SUMMARY OF CHANGES:

S4.55
DEVELOPMENT APPLICATION

COVER SHEET

URBN SURF SYDNEY
HILL ROAD, SYDNEY OLYMPIC PARK NSW

DRAWING
**SURFACE FINISHES
AND MATERIALS**

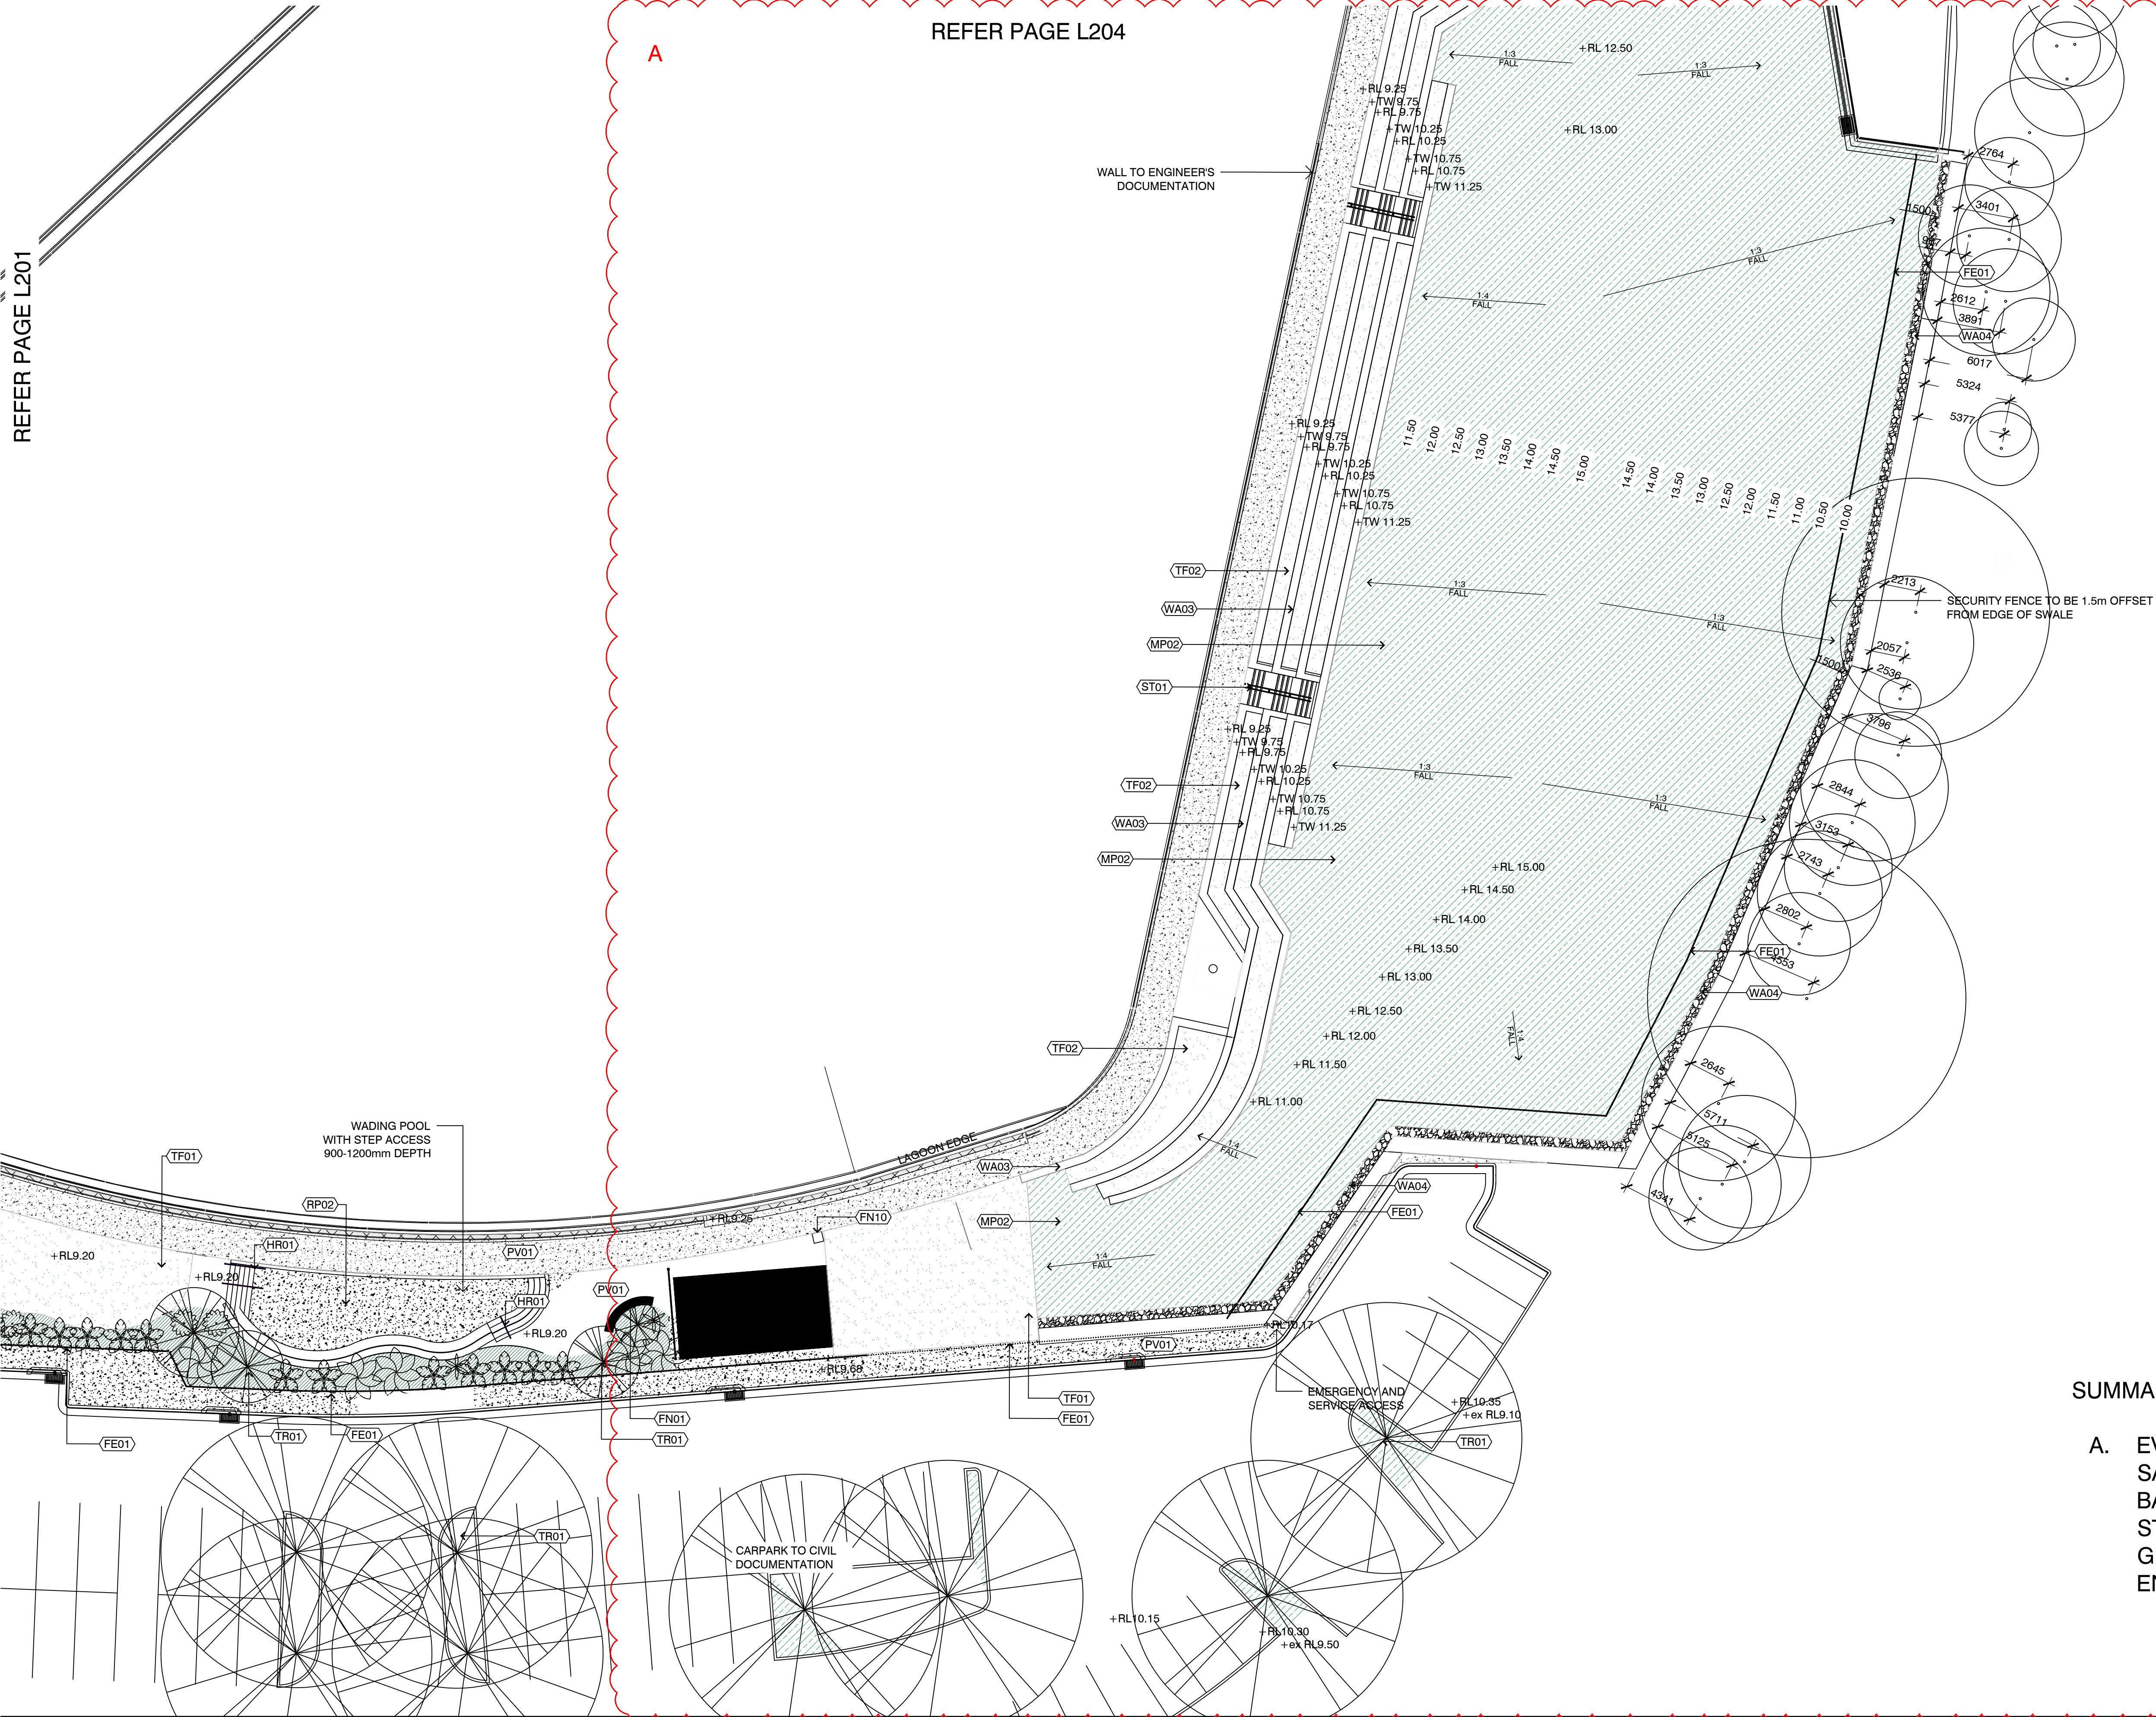
- A. EVENTS HILL DESIGN UPDATED WITH SANDSTONE BLOCK SEATING WALL TO BASE OF HILL ALONG WITH SANDSTONE STAIRS. EVENTS HILL RE-GRADED TO GENERALLY 1:3 REFER TO CIVIL ENGINEER'S DOCUMENTATION

DRAWING
**SURFACE FINISHES
AND MATERIALS**

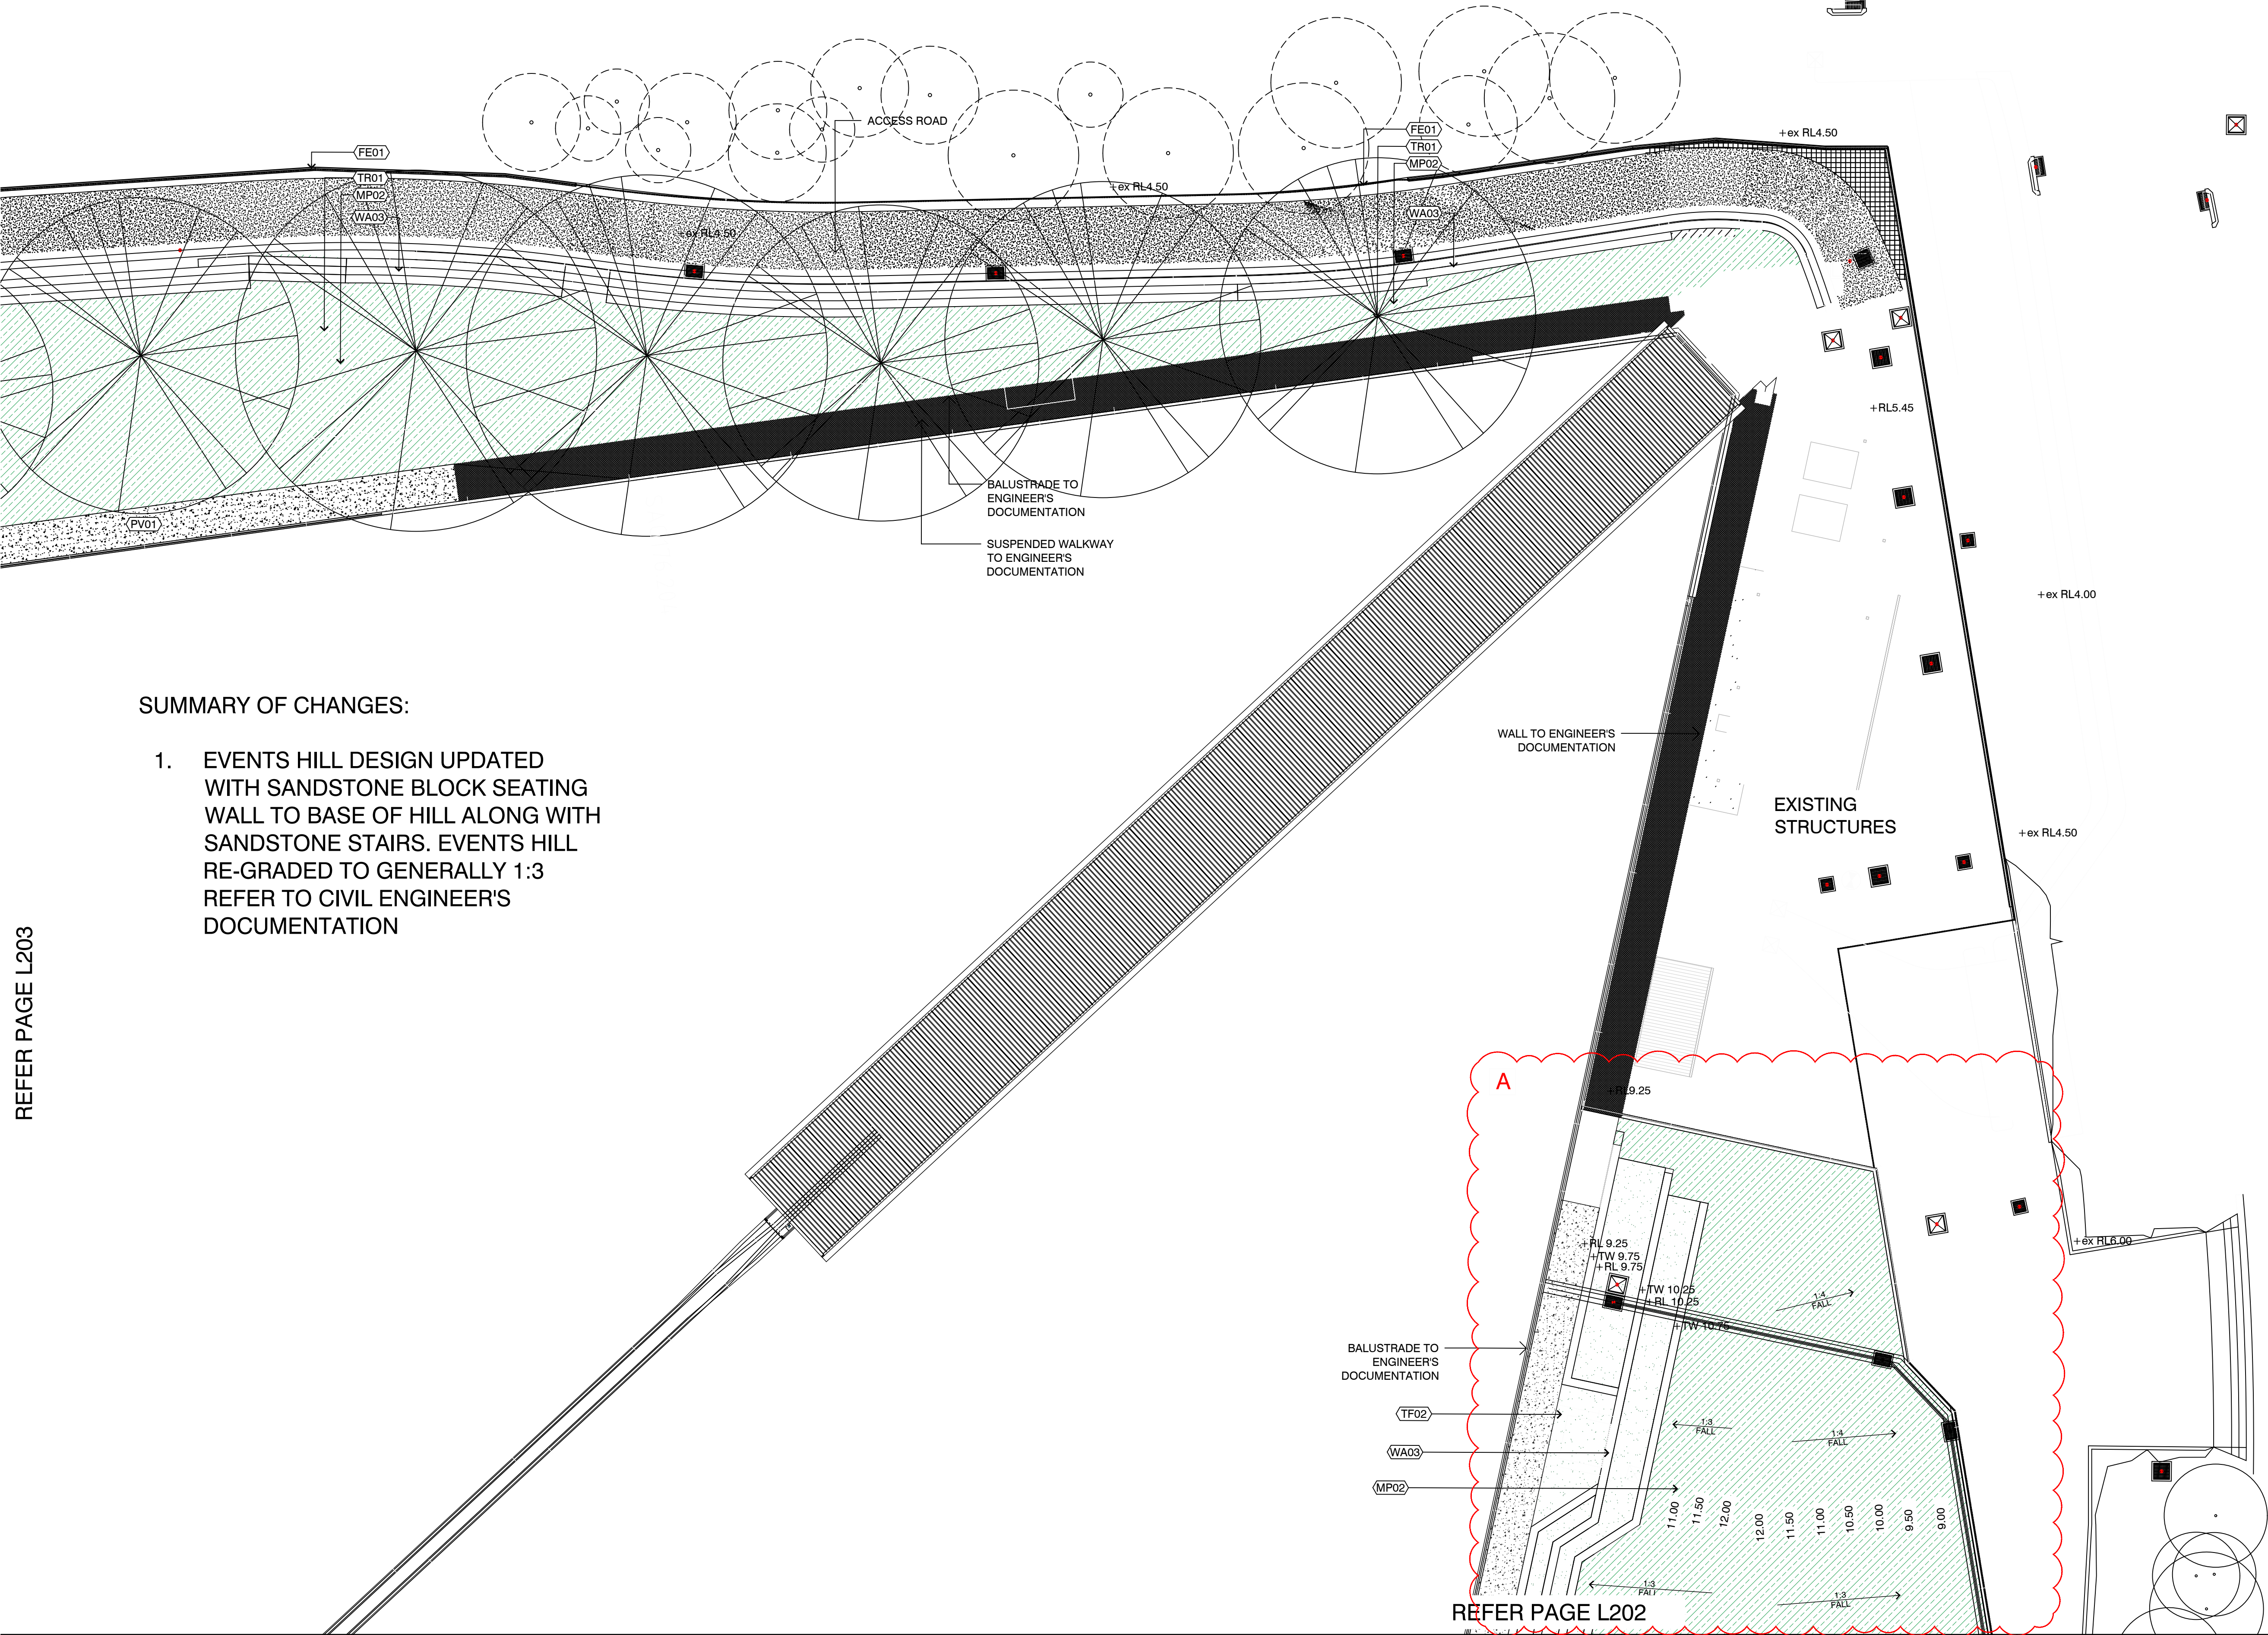
1. EVENTS HILL DESIGN UPDATED WITH SANDSTONE BLOCK SEATING WALL TO BASE OF HILL ALONG WITH SANDSTONE STAIRS. EVENTS HILL RE-GRADED TO GENERALLY 1:3 REFER TO CIVIL ENGINEER'S DOCUMENTATION

DRAWING
SECTIONS & ELEVATIONS
SECTION LOCATION PLAN

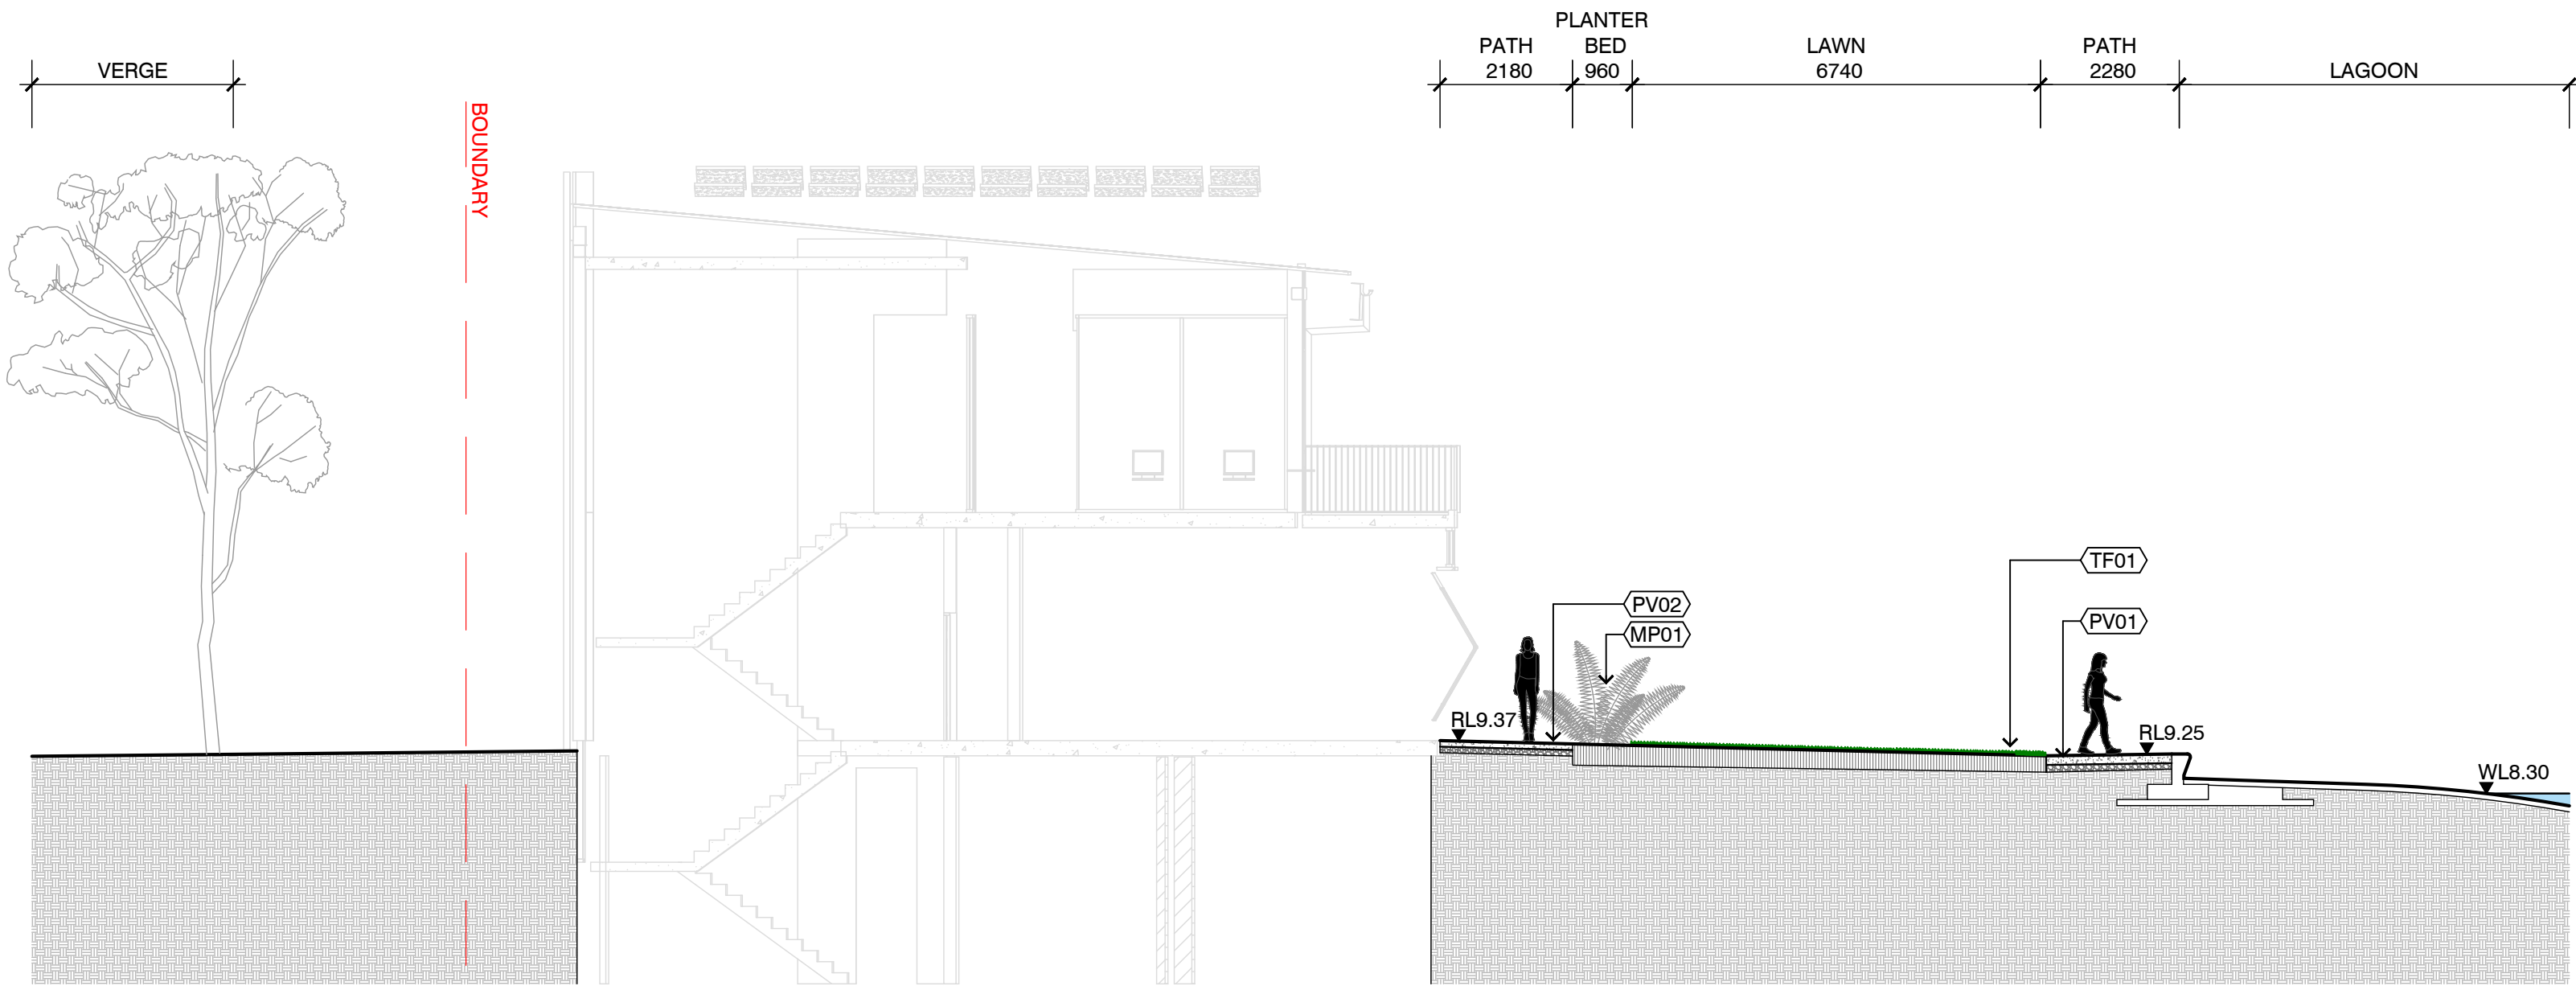
A. ADDITIONAL SECTIONS TO EVENTS HILL
